Access Compliance Report

Public Rights-of-Way

(Curb Ramps)

Intersection ID: 30003	Main Street: CHEPSTOW_CT	Cross Street: KEMPSFORD_DR	Location:	W
ADA ID: 23CABF222639	Ramp Type: PerpDiag	Initial Pass/Fail: Fail	Overall Compliance: No	Severity Score: 1.25
Codes/Mitigation Info/Possible Solution		Field Measurements/Component Compliance

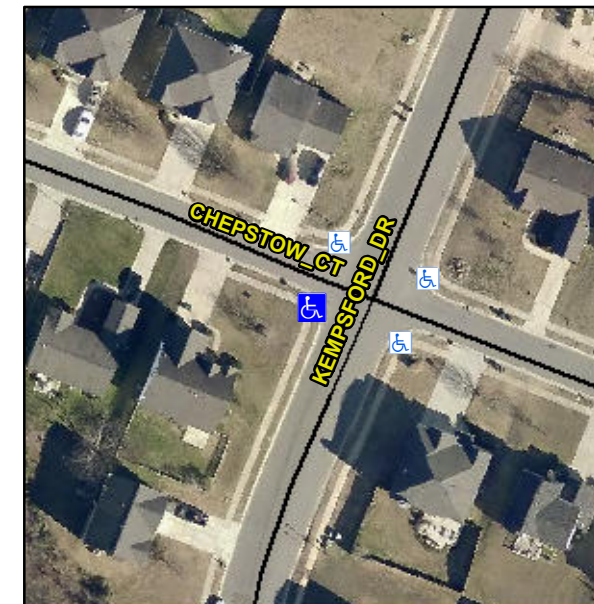
Not Found, R304.5.3

Compliance	Description	Data	Compliance	Description	Data
N/A	Ramp Length (in)	46.0	Yes	Ramp Slope (%)	5.1
Yes	Ramp Width (in)	55.0	No	Ramp XSlope (%)	2.5
N/A	Flare Type LT	N/A	N/A	Flare Type RT	N/A
N/A	Flare Slope LT (%)	N/A	N/A	Flare Slope RT (%)	N/A
N/A	Flare Traversable LT?	N/A	N/A	Flare Traversable RT?	N/A
N/A	Landing Length (in)	N/A	N/A	DWS Provided?	N/A
N/A	Landing Width (in)	N/A	N/A	DWS Contrast?	N/A
N/A	Landing Slope (%)	N/A	N/A	DWS Length (in)	N/A
N/A	Landing X Slope (%)	N/A	N/A	DWS Full Width?	N/A
N/A	Landing Curb? (Y/N)	N/A	N/A	DWS Offset (in)	N/A
N/A	Shared Landing?	N/A			
N/A	Gutter Ponding?	N/A	N/A	Gutter Slope (%)	N/A
N/A	Gutter Lip Ht (in)	N/A	N/A	Gutter X Slope (%)	N/A
N/A	Painted X Walk1?	No	N/A	Painted X Walk2?	No
	X Walk 1 Direction	To SE		X Walk 2 Direction	To NE
N/A	X Walk 1 Width (in)	N/A	N/A	X Walk 2 Width (in)	N/A
	X Walk 1 Slope (%)	4.3		X Walk 2 Slope (%)	0.0
	X Walk 1 X Slope (%)	0.6		X Walk 2 X Slope (%)	2.9

Remove & Replace Curb Ramp With Two New Directional Ramps or Equivalent.
